Site Instruction

SI 36

PROJECT : Hampton Manor
PROJECT No : 1136.13
DATE : June 11, 2019

Title: Revised South Exit Stair

1:100 A301

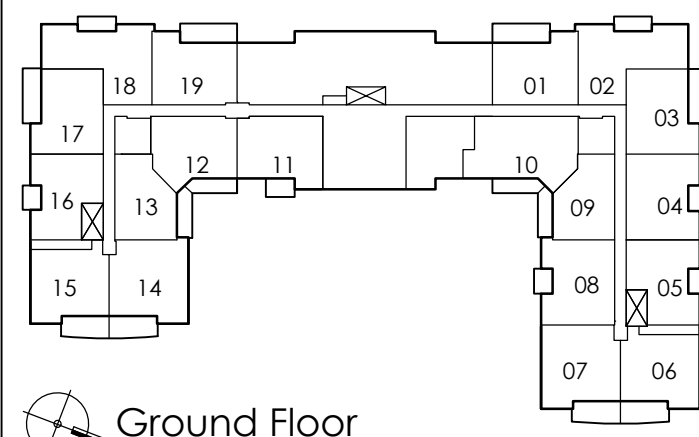
A301, A301a – Overall & Partial Ground Floor Plan

- Revision to South exit stair to match grading.

1:20 A606
TITLEBLOCK SIZE: 915 x 1400

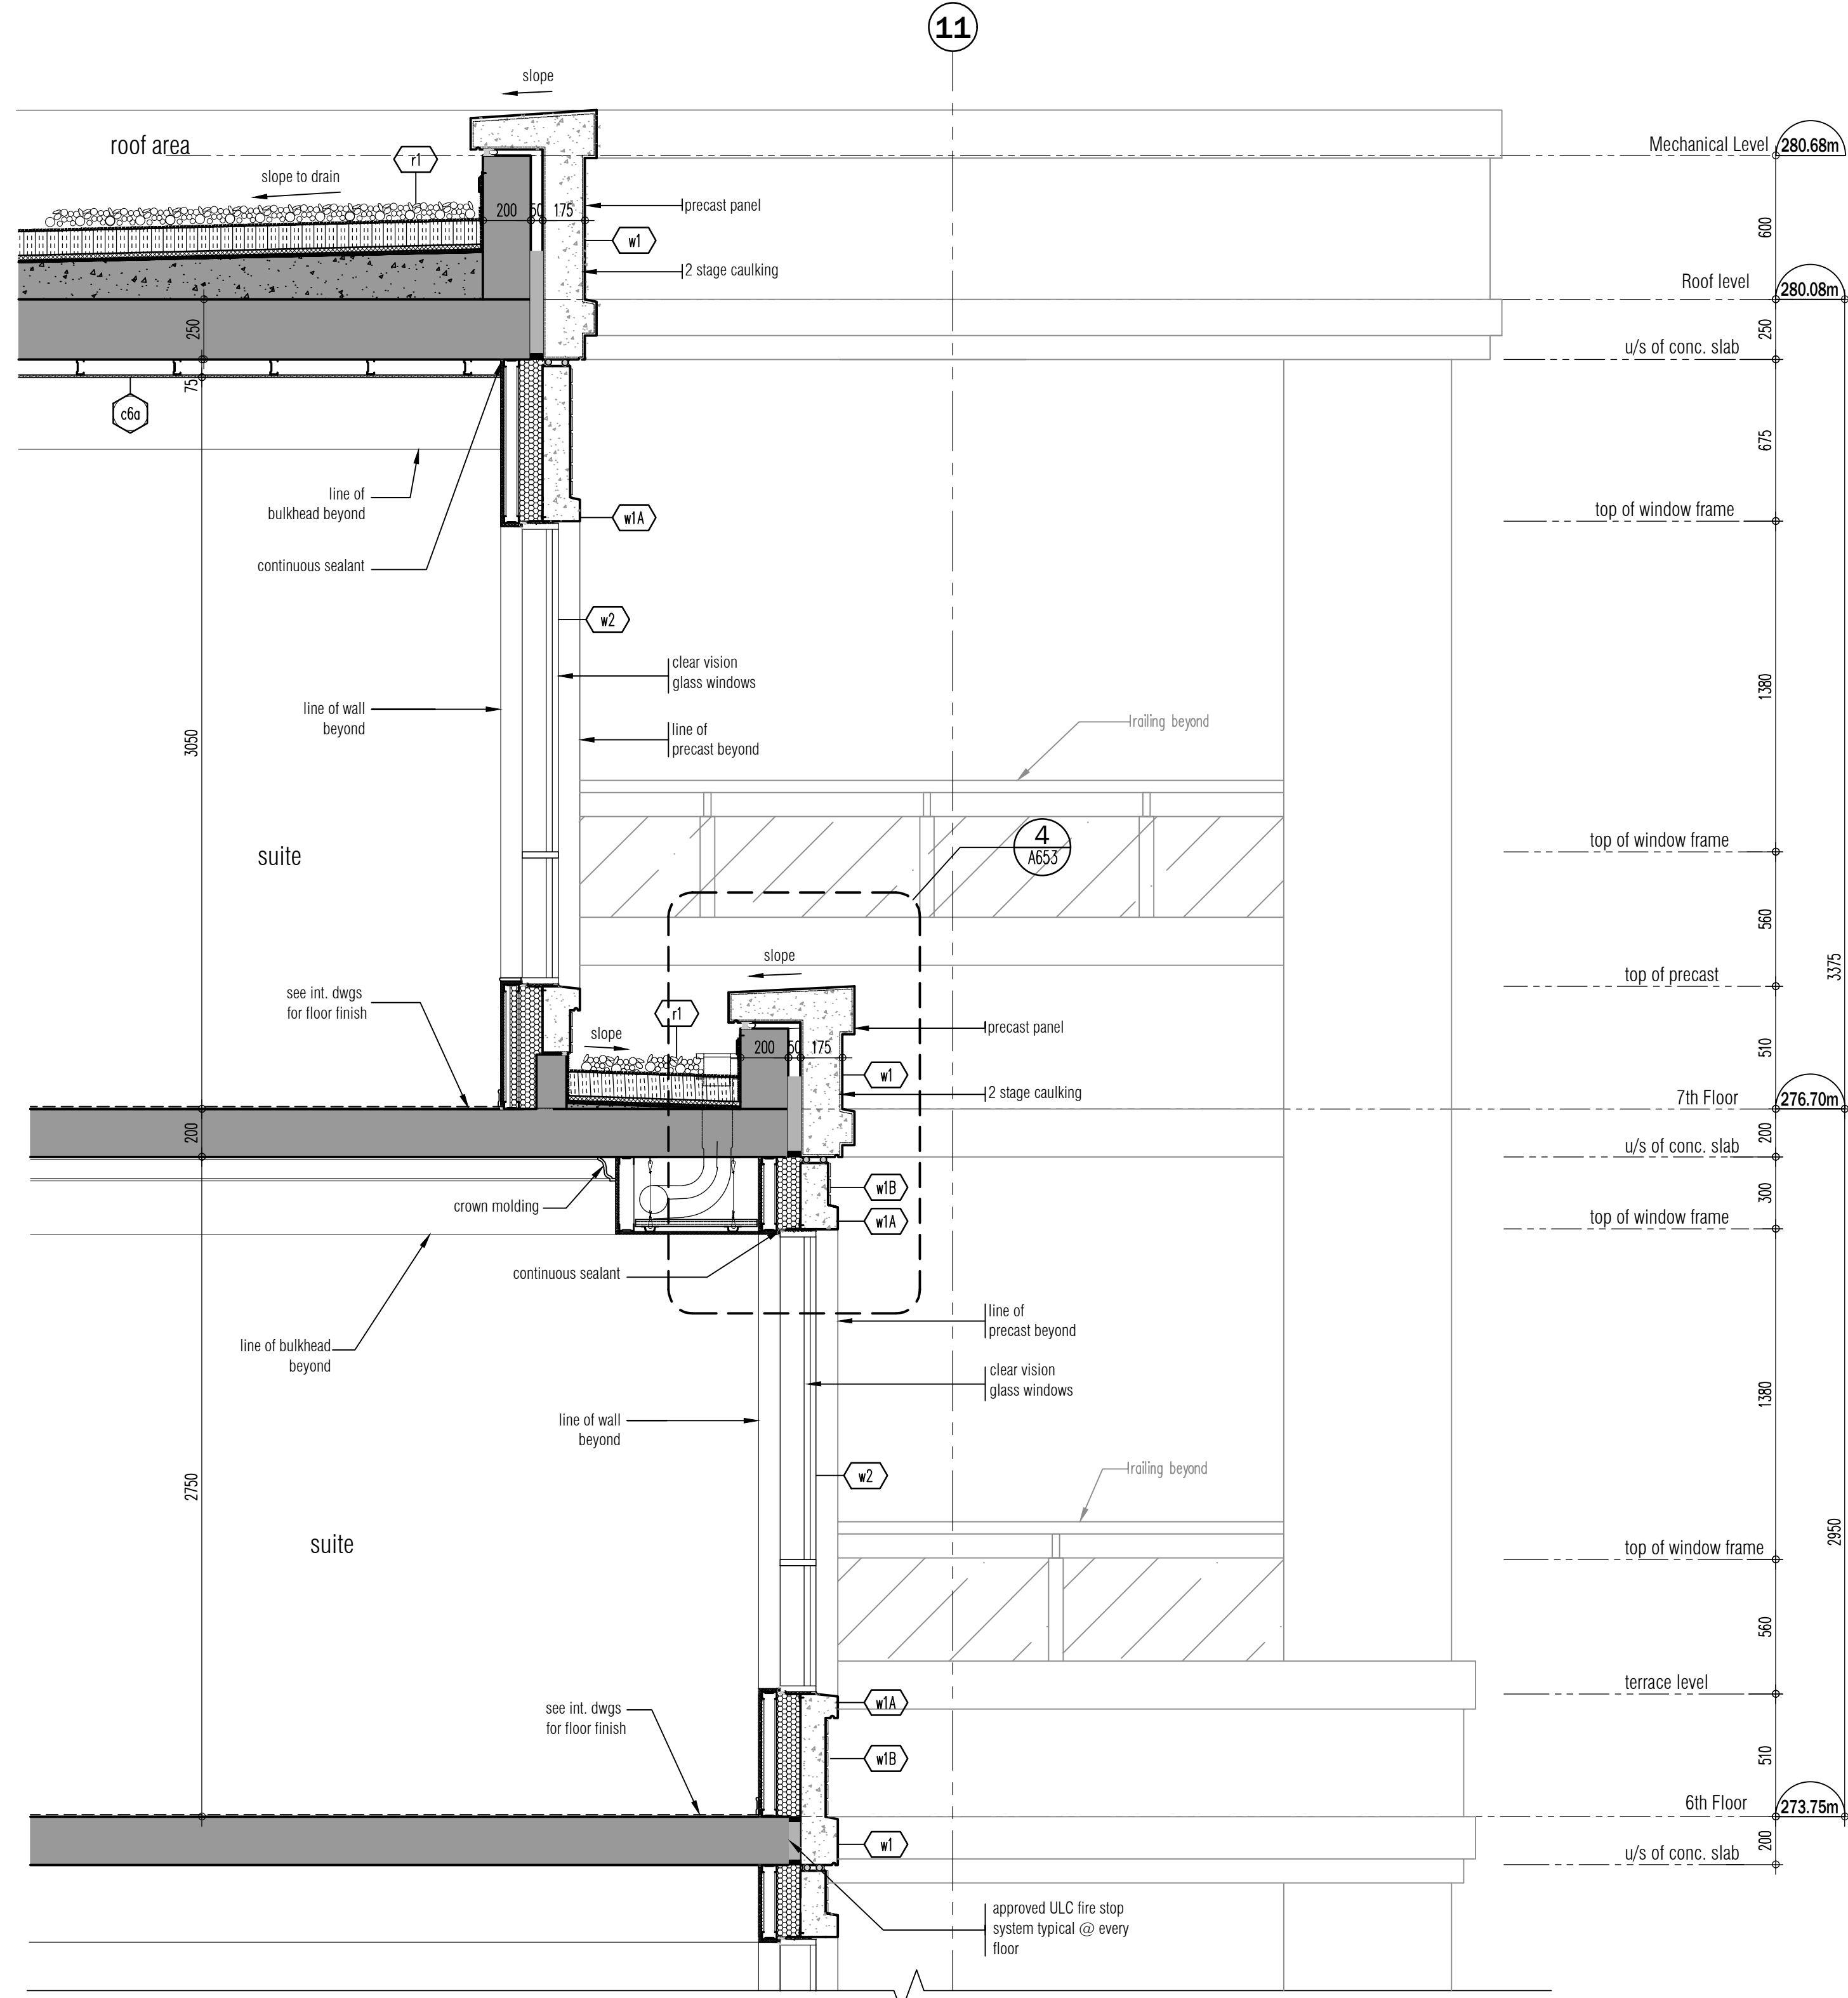
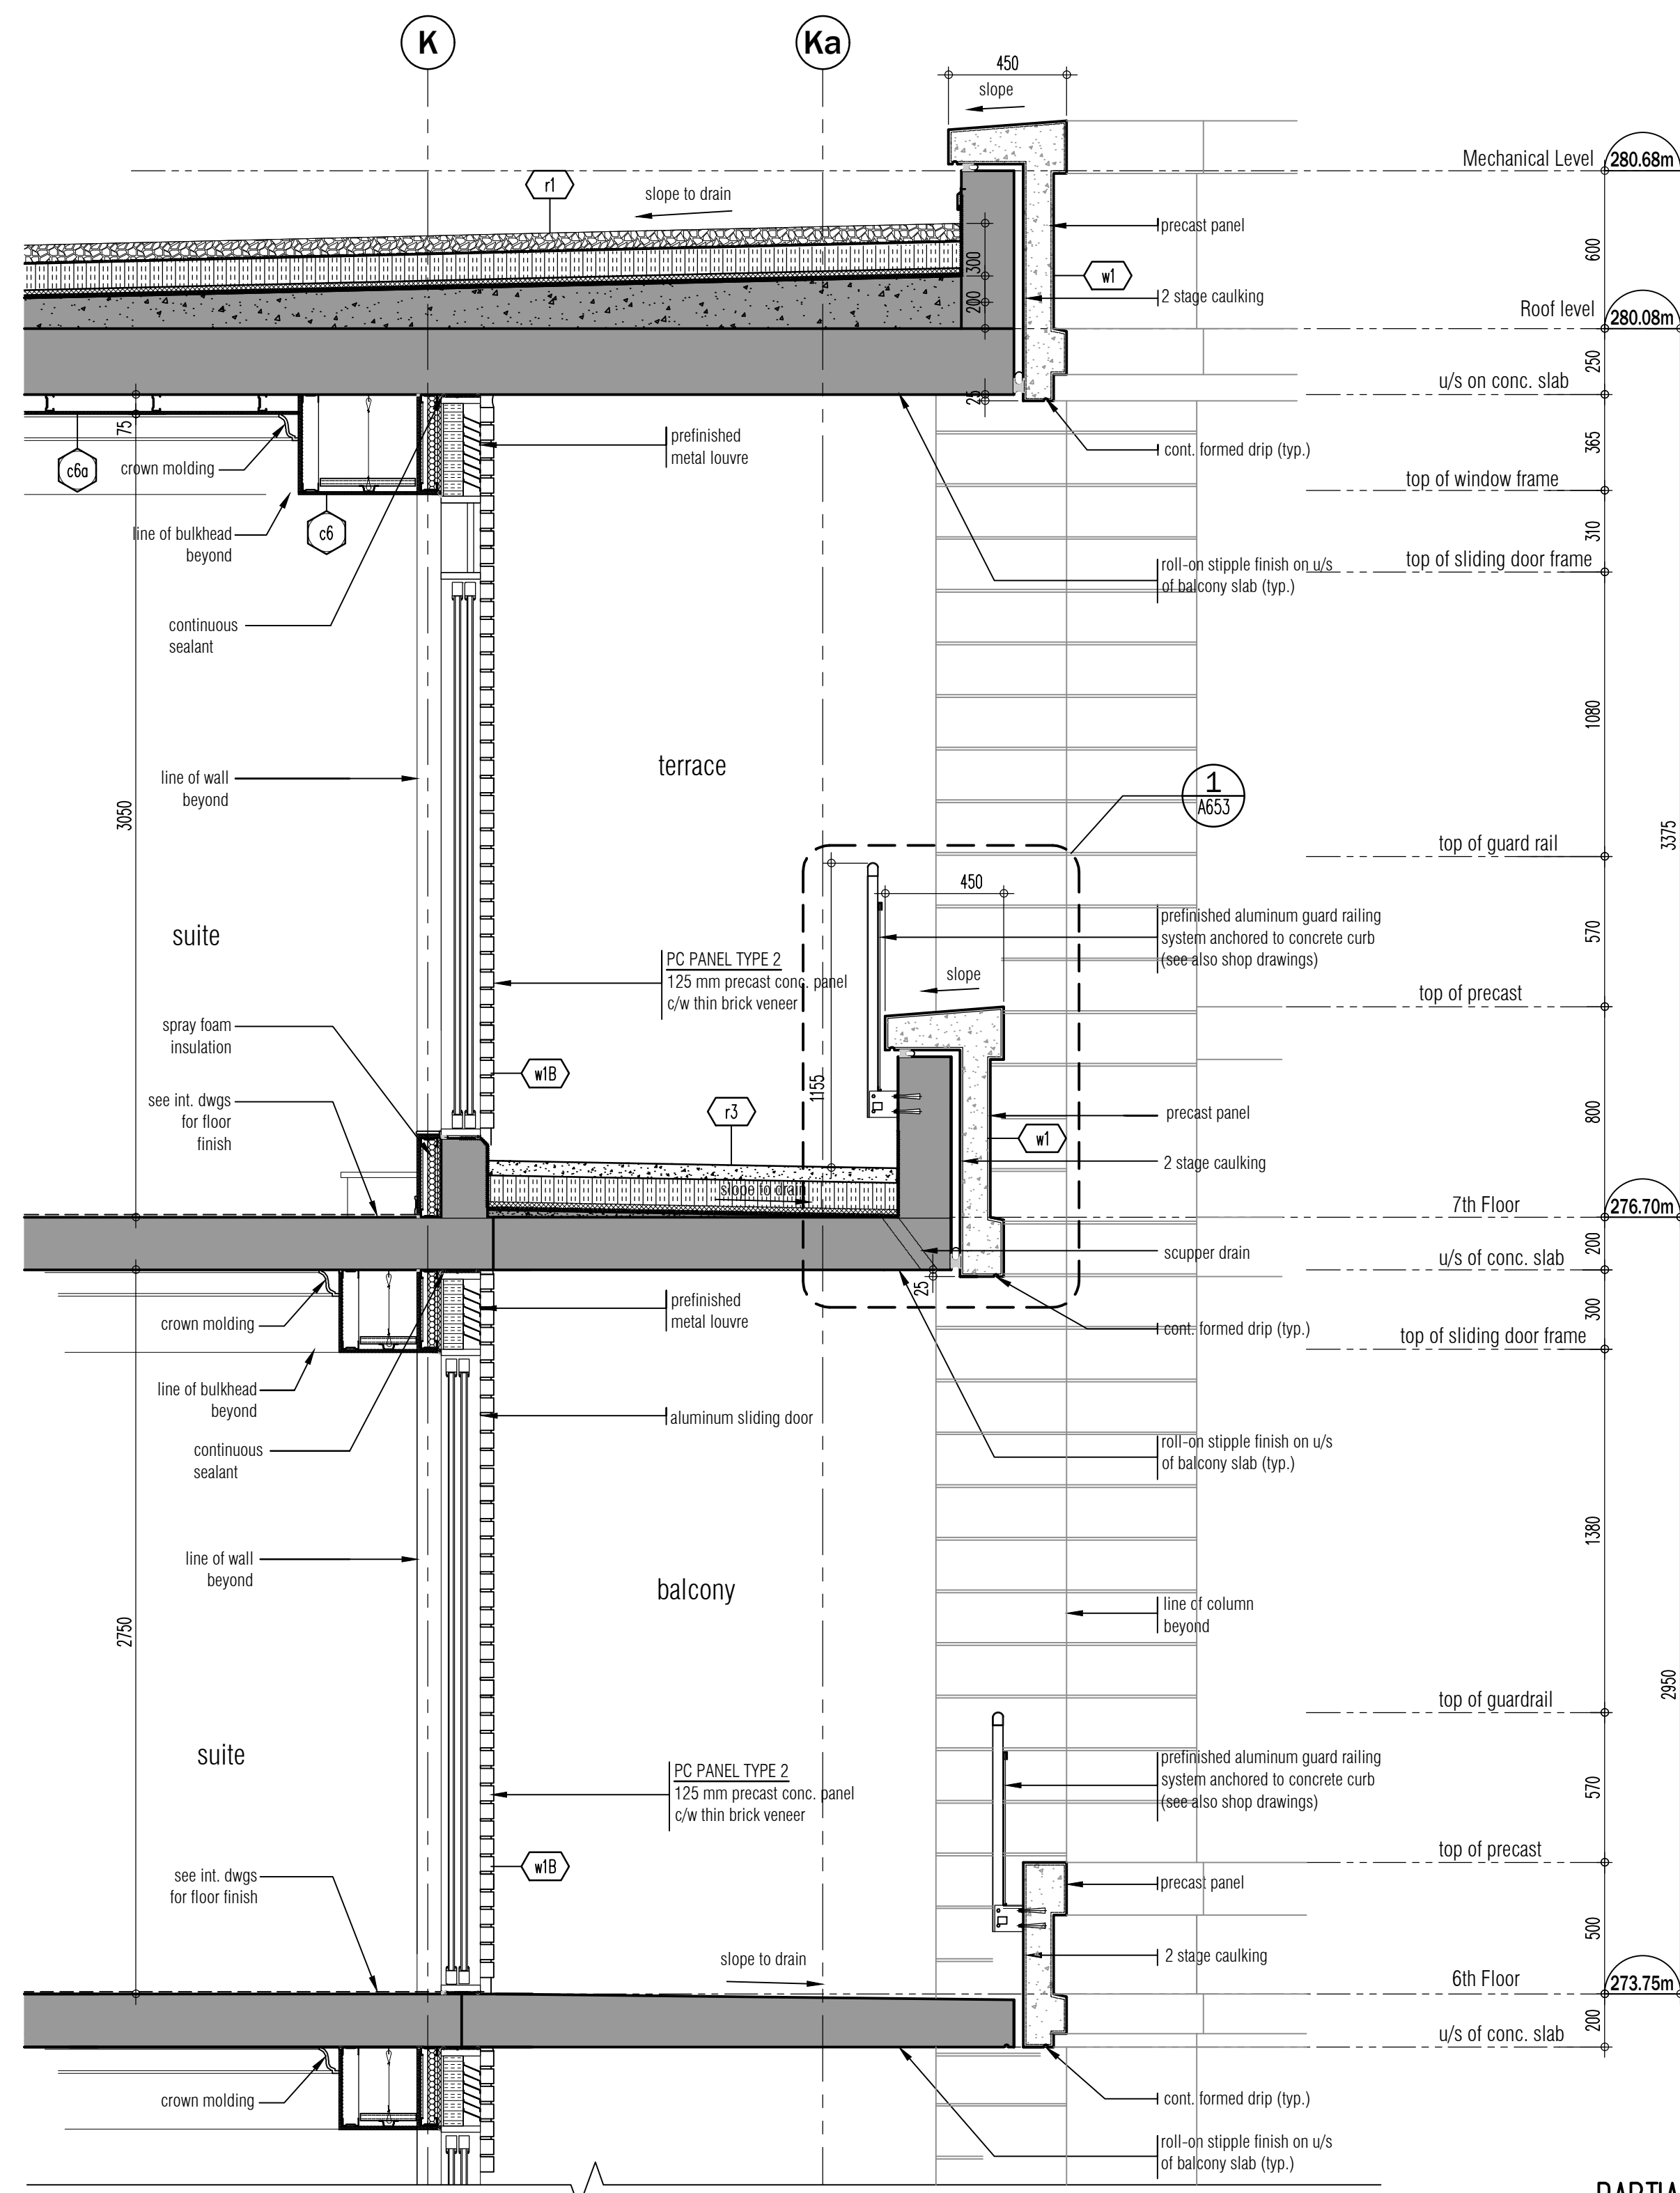
A606 – Partial Wall Section

- Revision to South exit stair to match grading.
